**Landscape Review Committee**  
**ZOOM Online Meeting**  
**Wednesday, May 19, 2021 - 12:00 PM**

DATE: May 19, 2021  
TO: Landscape Review Committee Members  
FROM: Jamie Fleckenstein, Associate Planner  
SUBJECT: Agenda Item 4A – Landscape Plan Review Application (L 37-20)

**DECISION, CONDITIONS, FINDINGS OF FACT AND CONCLUSIONARY FINDINGS FOR THE APPROVAL OF A LANDSCAPE PLAN REVIEW FOR A NEW INDUSTRIAL DEVELOPMENT AT 1300 NE MILLER STREET**

**DOCKET:** L 37-20 (Landscape Plan Review)

Figure 3: Landscape Plan

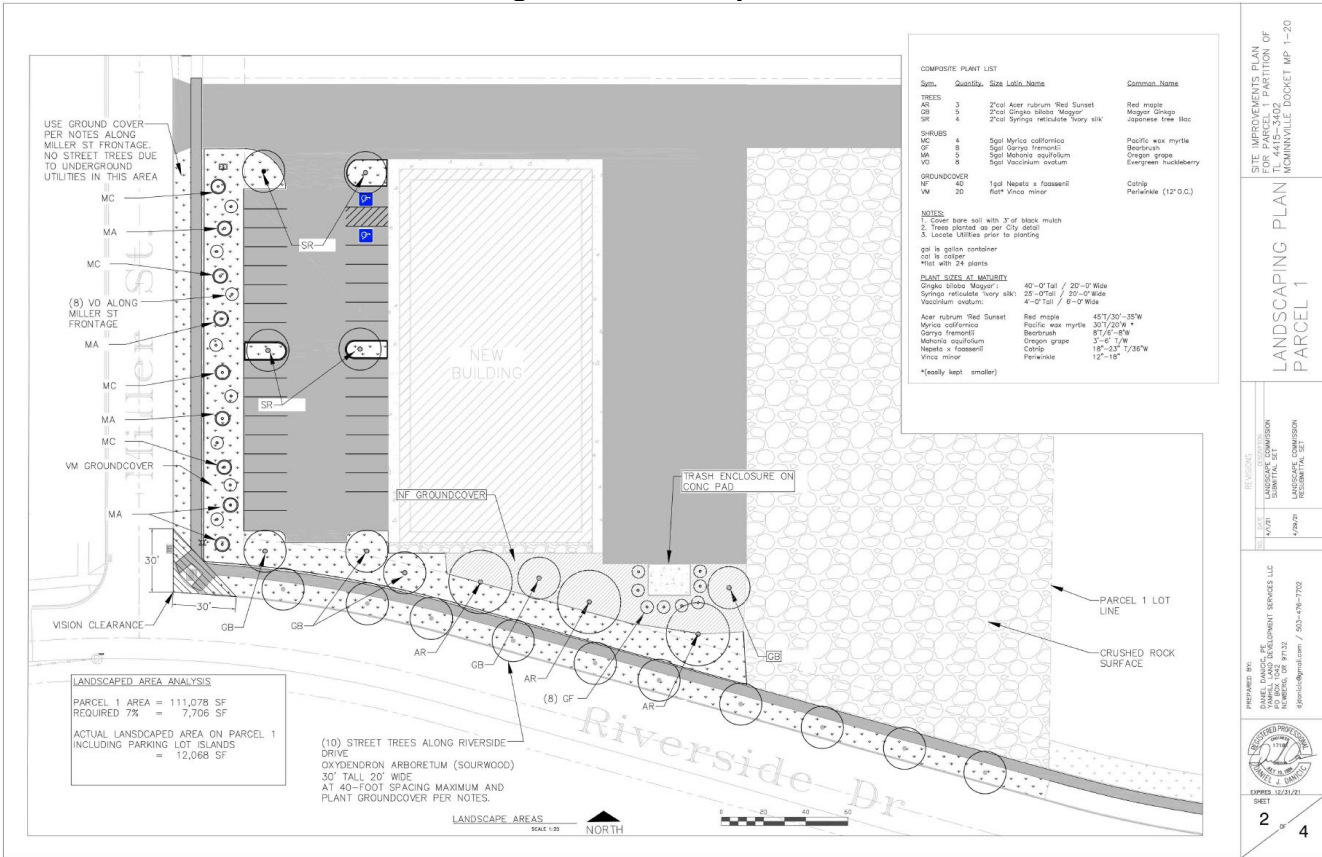
No street trees are proposed for the planter strip along Miller Street, and as discussed in findings below for Chapter 17.58-Trees, the presence of a storm drain line in the planter strip for the length of the Miller Street frontage would preclude street trees from the right-of-way adjacent to the property. The planting strip is proposed to be planted with *Vinca minor* (Periwinkle), an evergreen flowering groundcover.

Proposed planting in the landscape area between the sidewalk and parking lot includes native evergreen shrubs *Vaccinium ovatum* (Evergreen Huckleberry), *Myrica californica* (Pacific Wax Myrtle), and *Mahonia aquifolium* (Oregon Grape). Oregon Grape and Evergreen Huckleberry can reach six (6) feet tall and five (5) feet wide in maturity. Pacific Wax Myrtle is a larger shrub/small

The landscape area extends into the parking lot via planting islands where the small deciduous tree *Syringa reticulata* 'Ivory Silk' (Ivory Silk Japanese Tree Lilac) is proposed. The planting islands are repeated on the opposite side of the parking lot adjacent to the building. Ivory Silk Japanese Tree grows to 25 feet tall and 20 feet wide. The planting islands will have *Vinca minor* (Periwinkle) as groundcover.

**FINDING: SATISFIED.** Two aisles of parking are proposed in the parking area west of the proposed new industrial building. The westernmost parking aisle adjacent to the landscape area has 17 parking stalls, broken up by an internal planting island. The eastern parking aisle adjacent to the building has 16 parking stalls, also broken up by an internal parking lot island. The parking aisles are each capped at the ends with landscape areas. The northern endcaps and the internal planting islands each have an Ivory Silk Japanese Tree Lilac and *Vinca minor* groundcover. The southern endcaps are planted with Magyar Ginkgo trees and *Vinca minor* groundcover.

**FINDING: SATISFIED.** The landscape plan shows a trash enclosure located east of the proposed building in a location visible from the Riverside Drive right-of-way. Planting is proposed around the three sides visible from the right-of-way in the form of *Garrya fremontii* (Fremont Silktassel). *Garrya fremontii* is a native evergreen shrub that can reach at least nine (9) feet tall and wide. At the spacing provided around the trash enclosure, the proposed planting will grow into a continuous evergreen screen.

2. That *Oxydendron arboretum* (Sourwood) street trees shall be spaced at no greater than 30 feet apart.
3. That the applicant shall maintain proper clearances around the existing and future water and electrical services that will be located on the site. Landscaping shall not be placed within four (4) feet of fire hydrants, within four (4) feet of water valves, within four (4) feet of vaults, within three (3) feet of the back or side of a transformer, or within one (1) foot of water meters. Tree trunks shall not be placed within ten (10) feet of water meters. Minor adjustments in plant placement from the locations shown on the approved landscape plan are allowed if relocation is necessary to meet minimum clearances.

Figure 4: Irrigation Plan

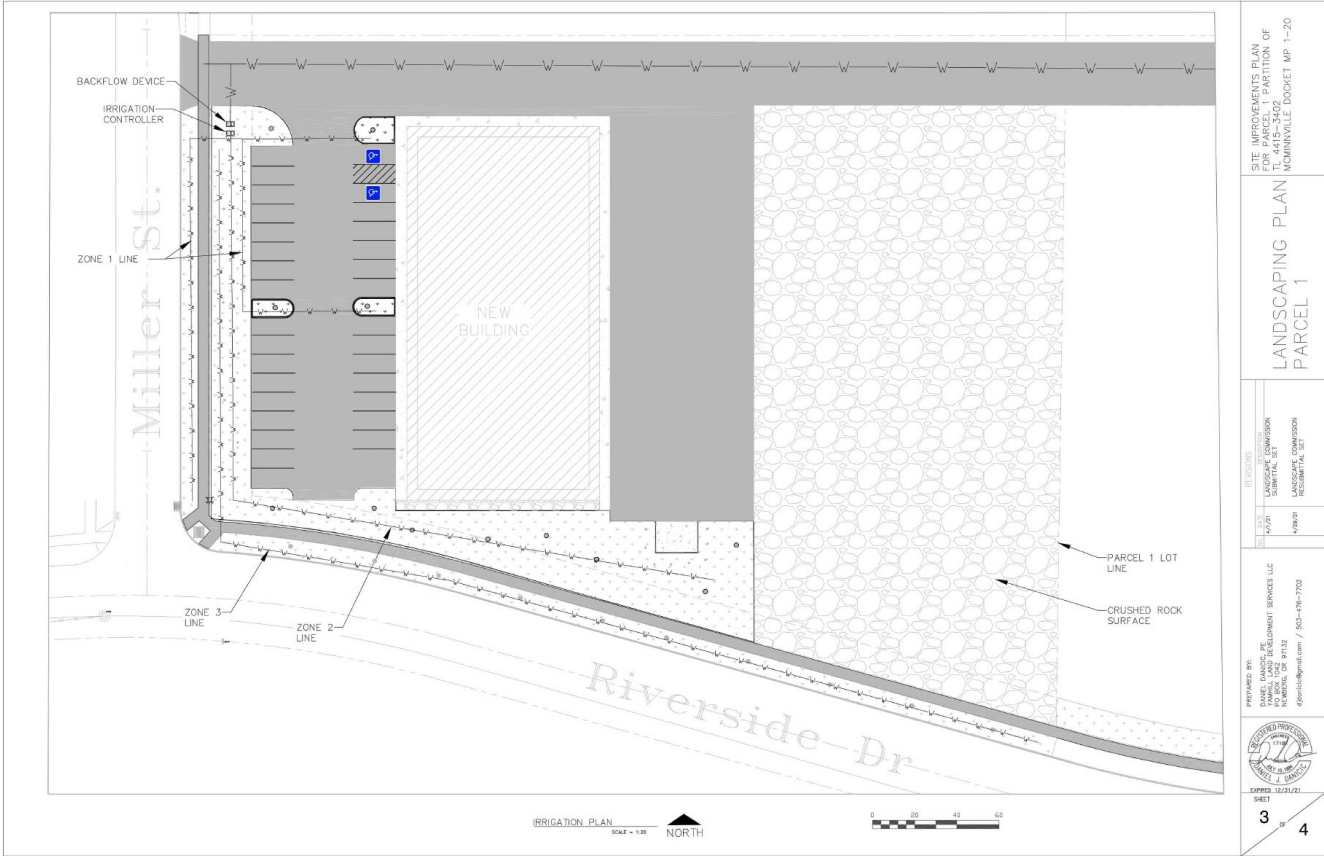
**FINDING: SATISFIED.** An irrigation plan was provided showing irrigation lines in the planted landscape areas along the south and west property lines and in the planter strips adjacent to the property. The plan provides the location of the water meter, double check valve, and three water zones. Zone 1 includes the Miller Street planter strip and parking lot islands, Zone 2 includes the larger landscape areas along the west and south property lines, and Zone 3 includes the Riverside Drive planter strip.

Figure 5: Site Utility Plan

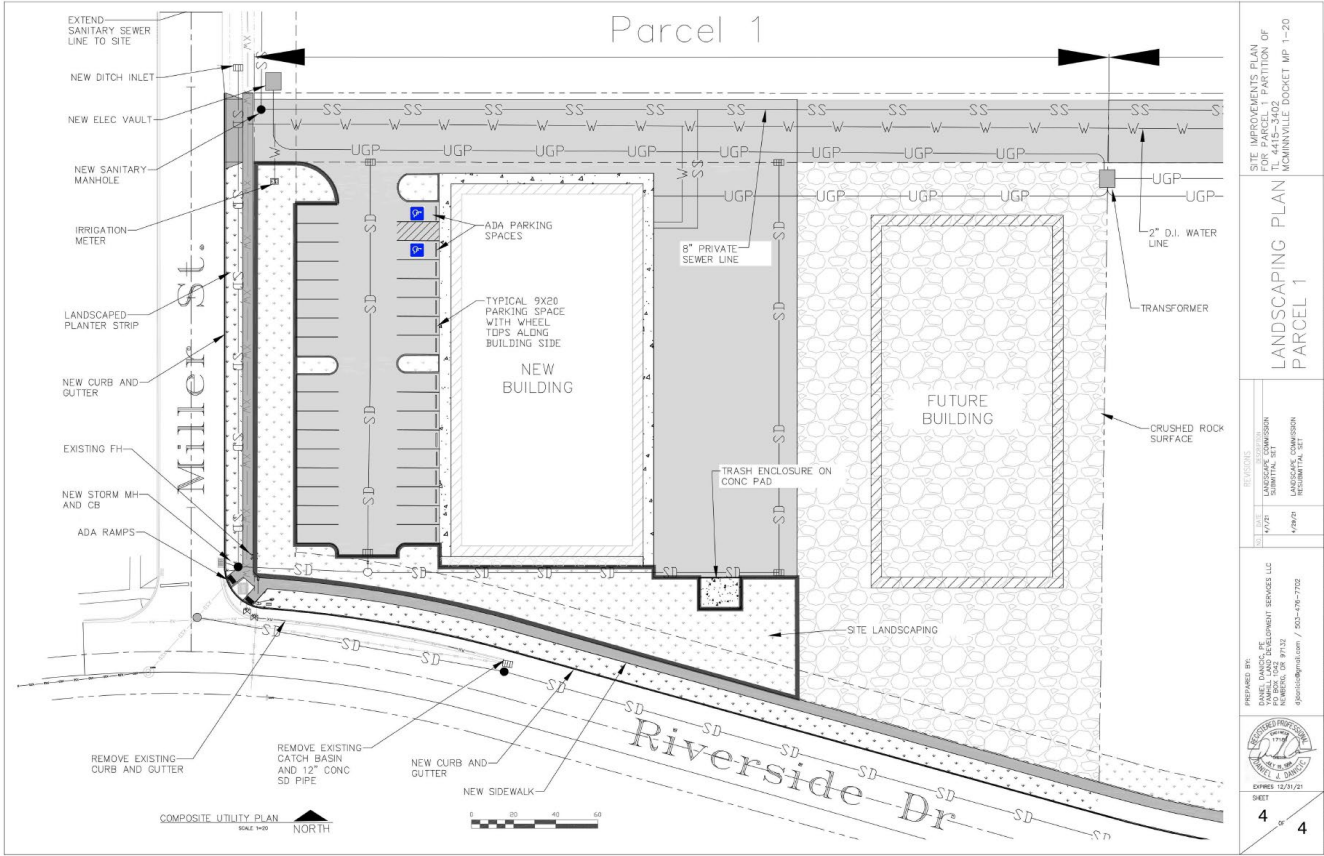
**FINDING: SATISFIED WITH CONDITION OF APPROVAL #6.** The site utility plan indicates that a storm drain line is located within the entirety of the planter strip along Miller Street adjacent to the subject site. The required setback from a storm line is ten (10) feet. Therefore, there is not sufficient space in the eight (8) foot wide planter strip along Miller Street to accommodate street trees. Additionally, a condition of approval has been included to ensure that setbacks from utilities to street trees be maintained.

6. That the applicant is reminded that street trees are not to be planted within:
  - a. Five (5) feet of a private driveway or alley;
  - b. Ten (10) feet of a fire hydrant, transformer, power or water vault, water meter box, utility pole, sanitary sewer, storm or water line; or

- c. Twenty (20) feet of street light standards or street intersections.
7. That planting of street trees shall be subject to the design drawings and specification developed by the City in May 2014. The applicant shall provide root barrier protection in order to minimize sidewalk and tree root conflicts. The barrier shall be placed on the public sidewalk side of the tree and the curb side of the tree. The root barrier protection shall be provided to a minimum depth of eighteen (18) inches. In addition, irrigation of street trees is approved in lieu of the standard requirement to provide two (2) deep watering tubes.
